To: T10 Committee (SCSI)

From: George Penokie (IBM/Tivoli)

Subject: SAS UML Corrections

Figure 6 — SAS domain class diagram

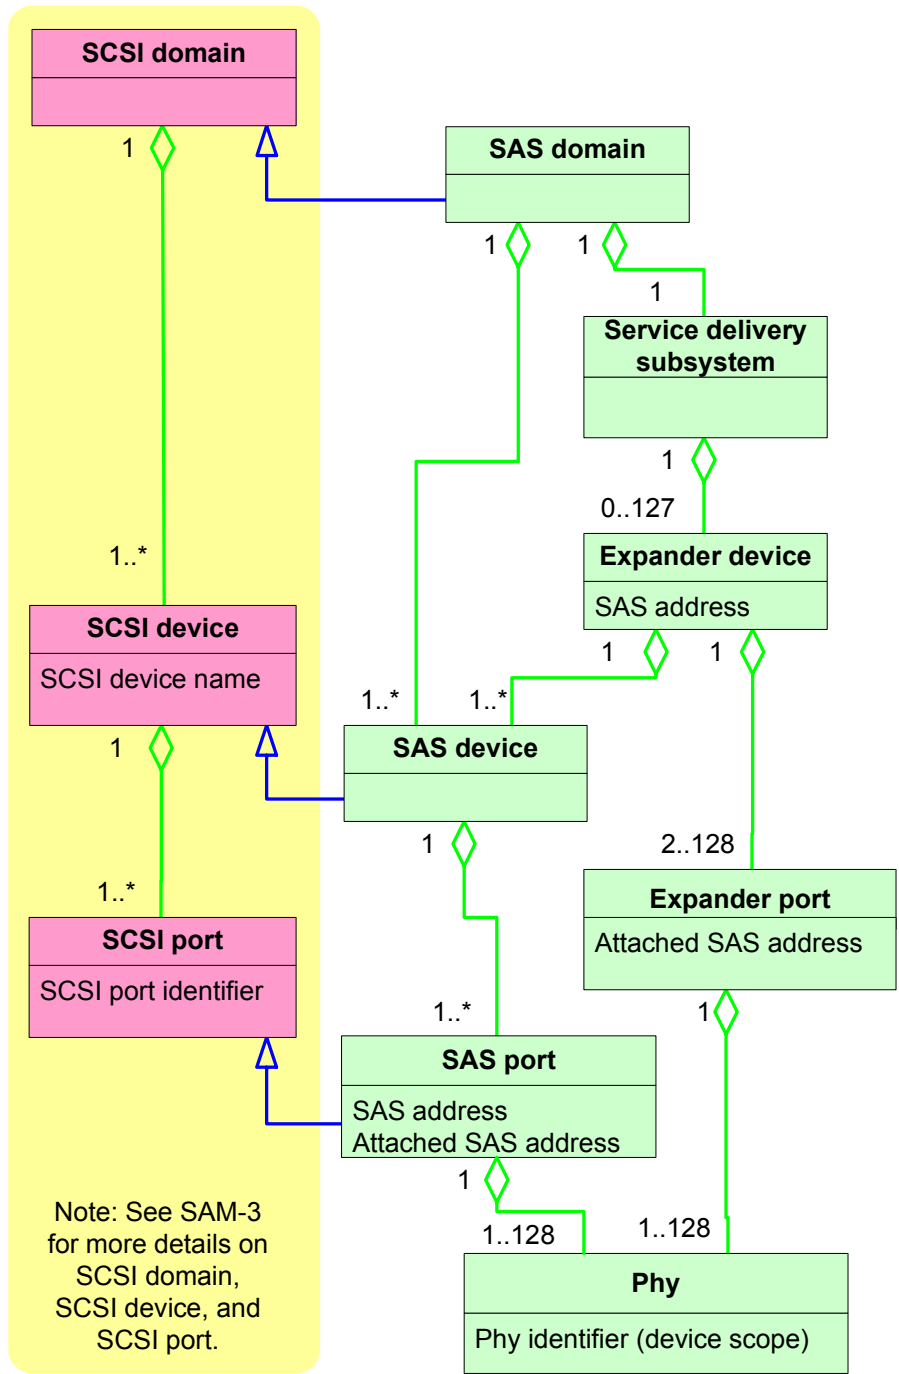
Figure 6 shows the class diagram for a SAS domain, showing the relationships between SAS domain, SCSI domain, service delivery subsystem, expander device, expander port, SAS device, SCSI device, SAS port, SCSI port, and phy classes. Relationships to ATA classes (e.g., ATA domain) are not shown in figure 6.

Figure 7 — Phy classes

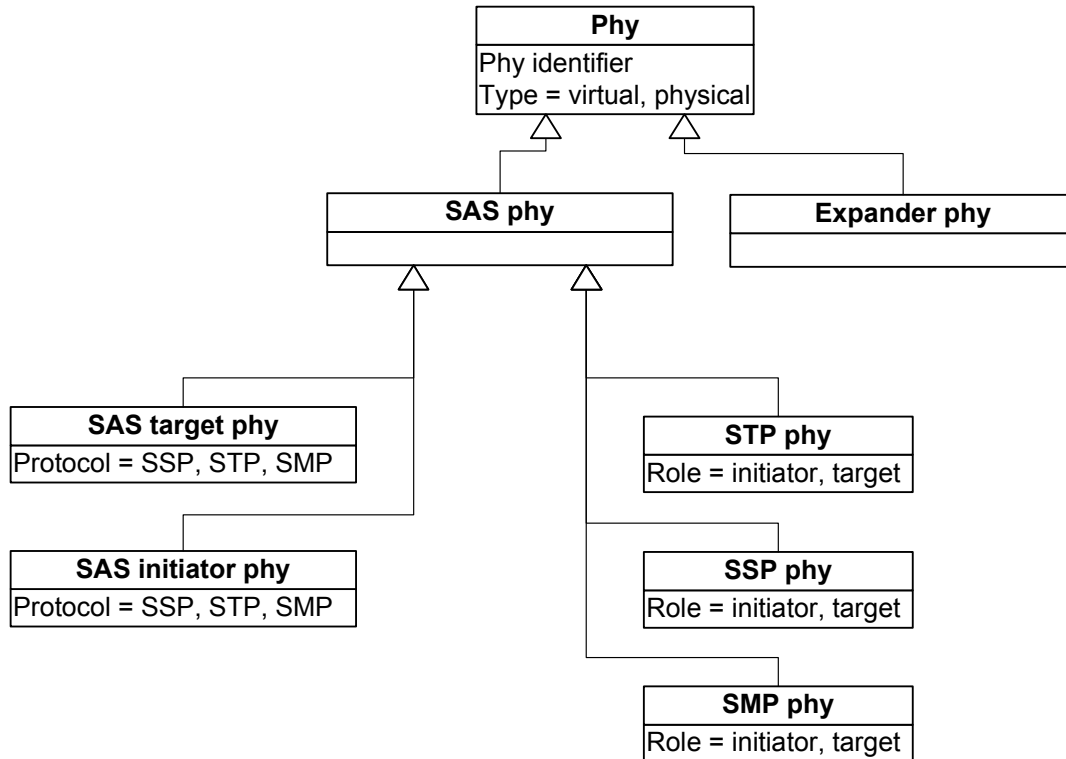
Figure 7 expands the phy class showing the relationships between the following classes:

- a) phy, SAS phy;
- b) SAS phy;
- c) SAS initiator phy;

- d) SAS target phy;
- e) SSP phy;
- f) STP phy;
- g) SMP phy classes; and
- h) expander phy.

Figure 9 — Port classes

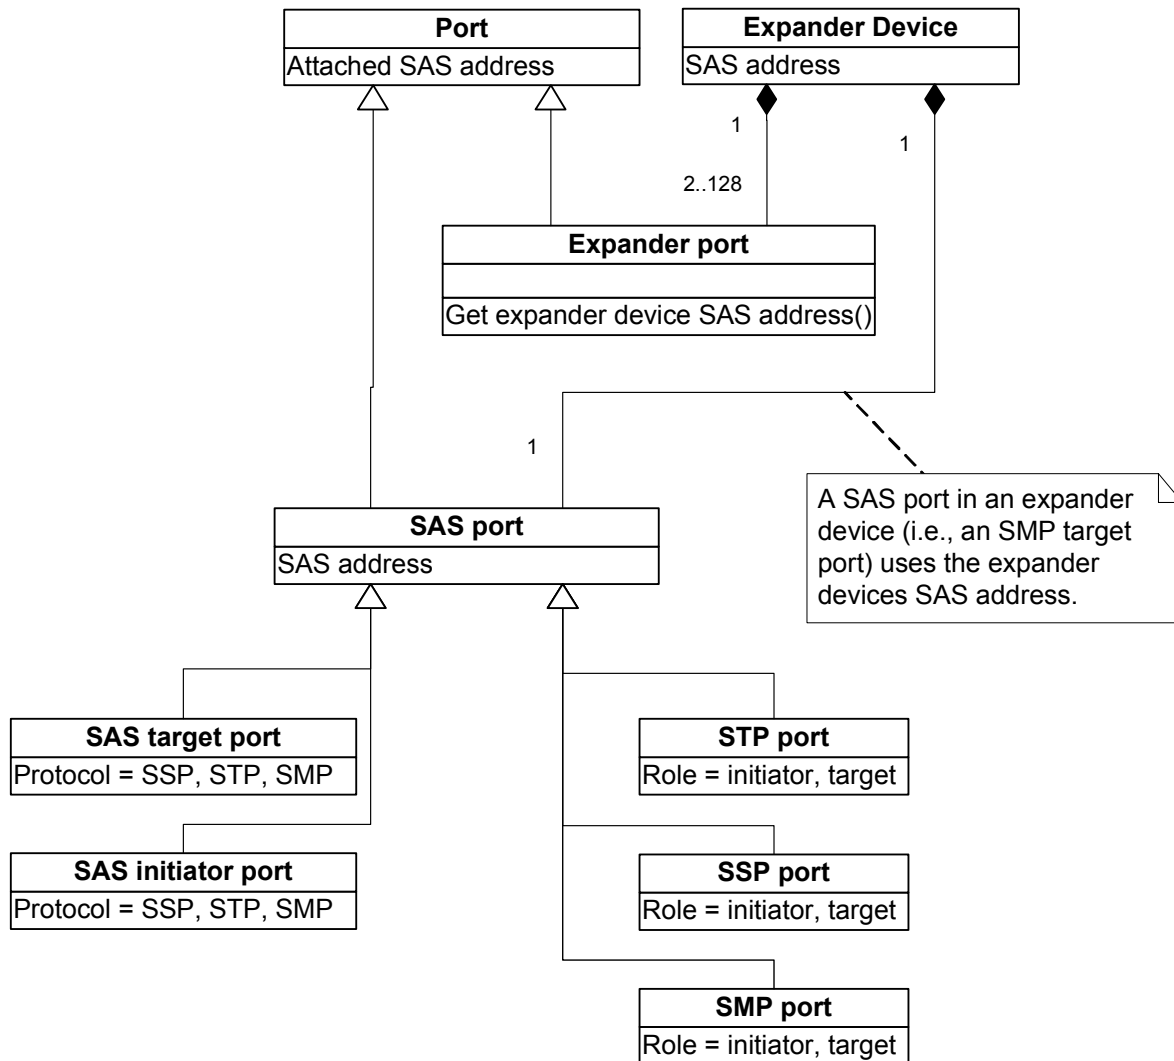
Figure 9 expands the port class and expander class to show the relationships between the following classes:

- a) port;
- b) expander device;
- c) expander port;
- d) SAS port classes;
- e) SAS target port;
- f) SAS initiator port;
- g) STP port;
- h) SSP port; and
- i) SMP port.

Figure 11 — Expander device classes

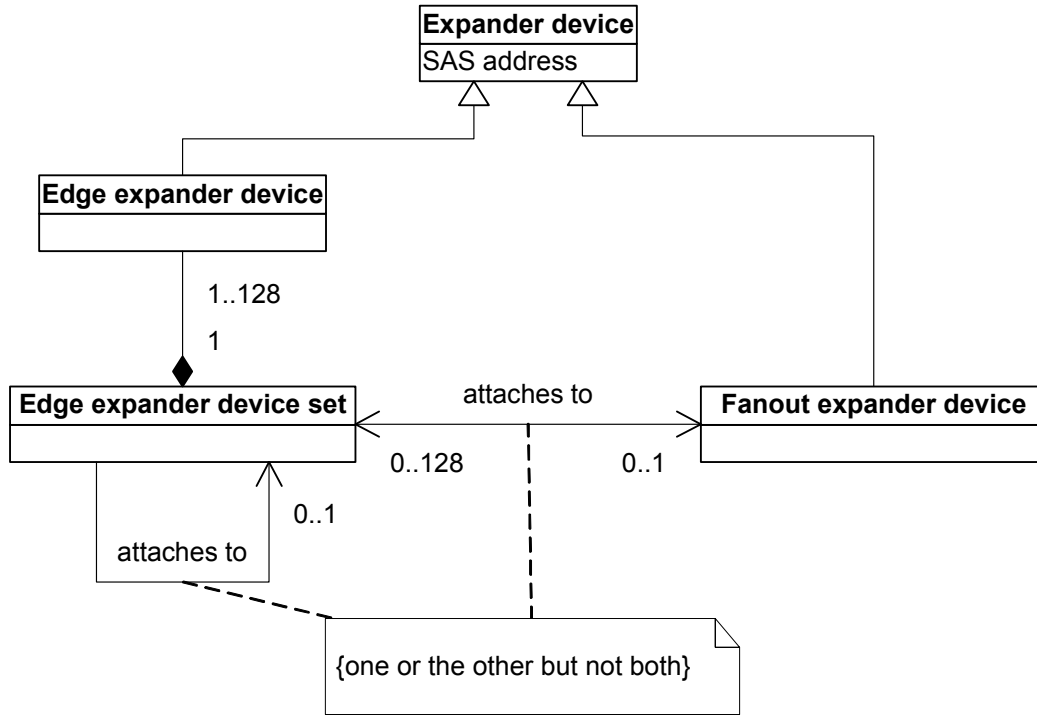
Figure 11 shows the expander device classes.

Figure 12 — State machines for SAS devices

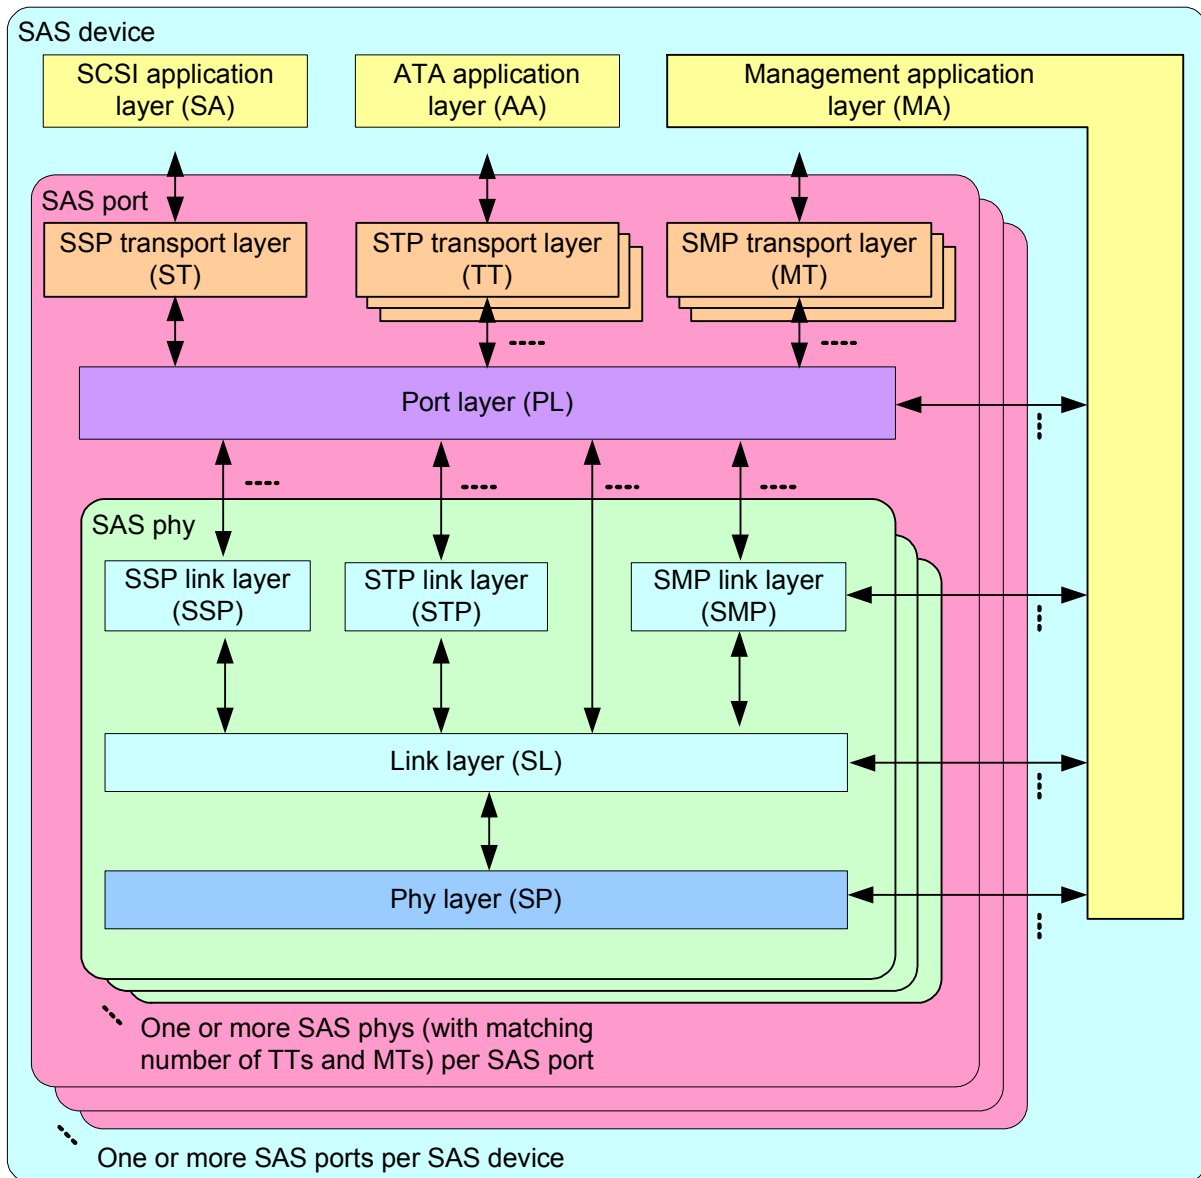
Figure 12 shows the state machines for SAS devices, their relationships to each other and to the SAS device, SAS port, and SAS phy.

Figure 13 — State machines for expander devices

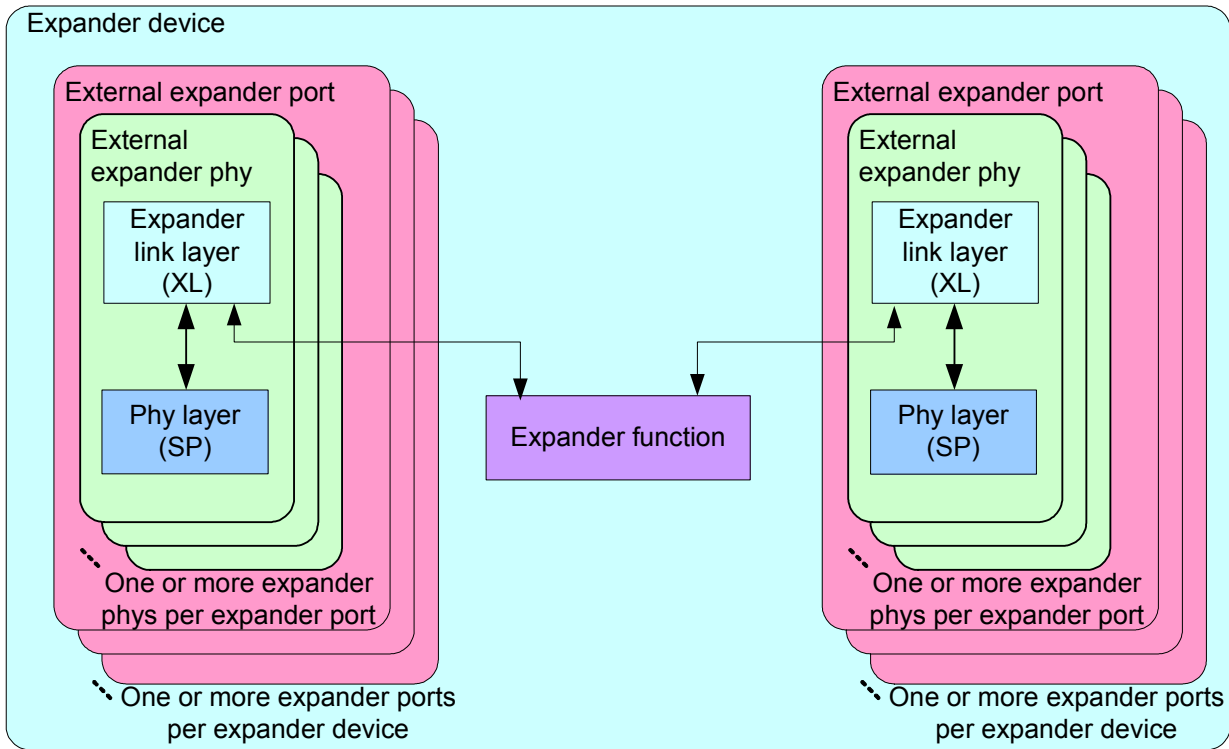
Figure 13 shows the state machines for expander devices, their relationships to each other and to the expander device, expander port, and expander phy. Expander function state machines are not defined in this standard, but the interface to the expander function is defined in 4.6.6.

Figure 14 — State machine and SAS device, SAS port, and SAS phy classes

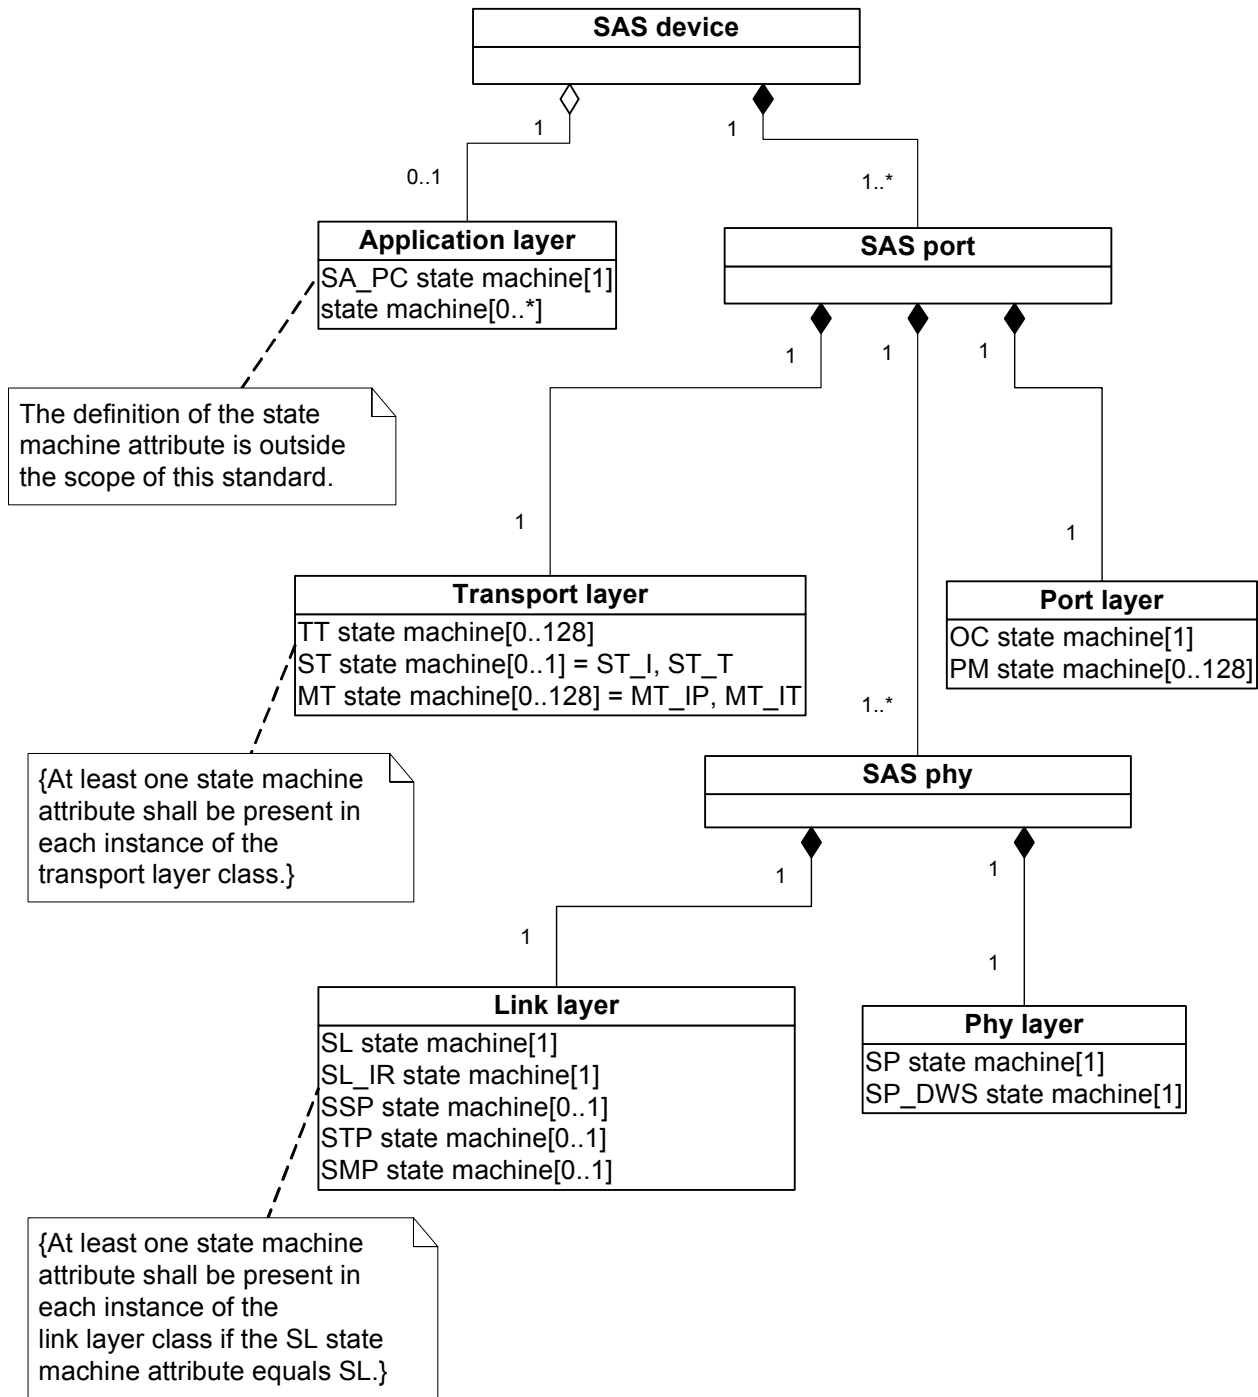
Figure 14 shows which state machines are contained within the SAS device, SAS port, and SAS phy classes.

Figure 15 — State machine and expander device, expander port, and expander phy classes

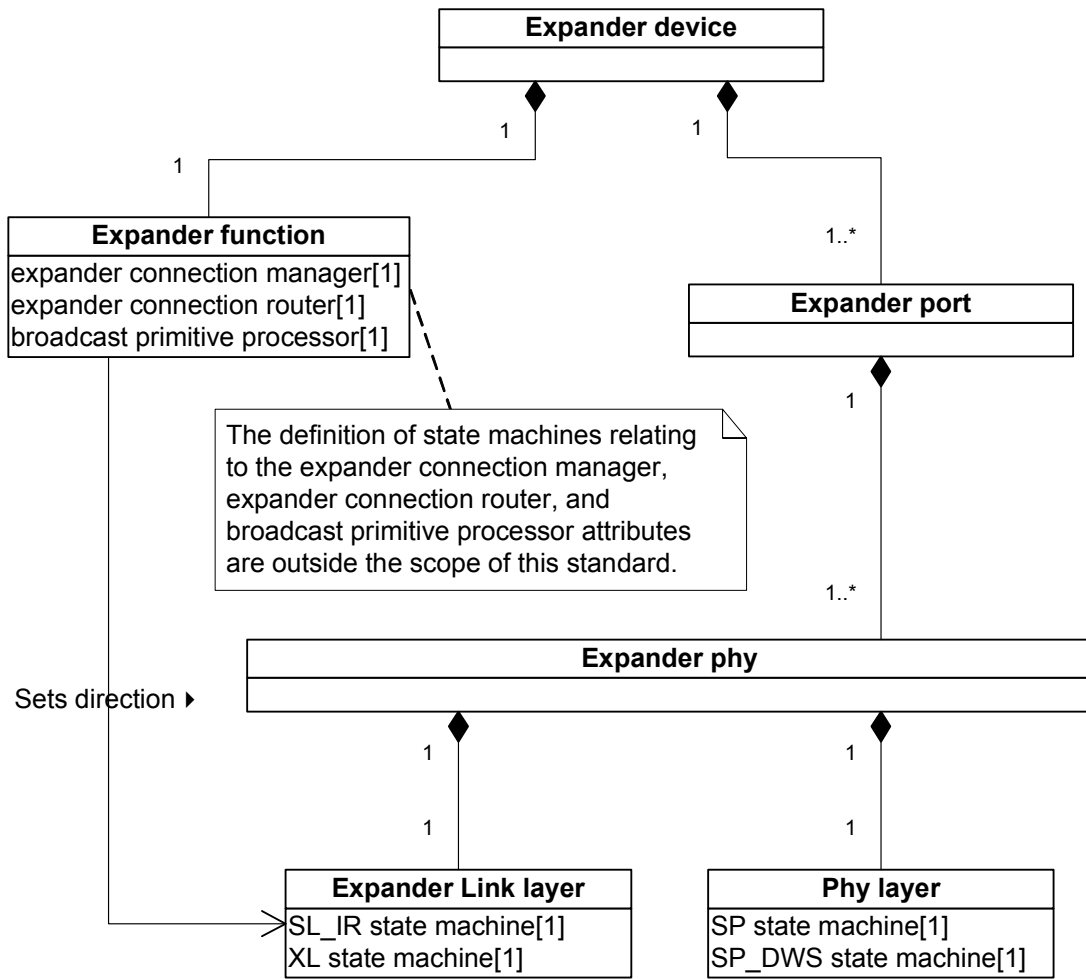
Figure 15 shows which state machines are contained within the expander device, expander port, and expander phy classes.
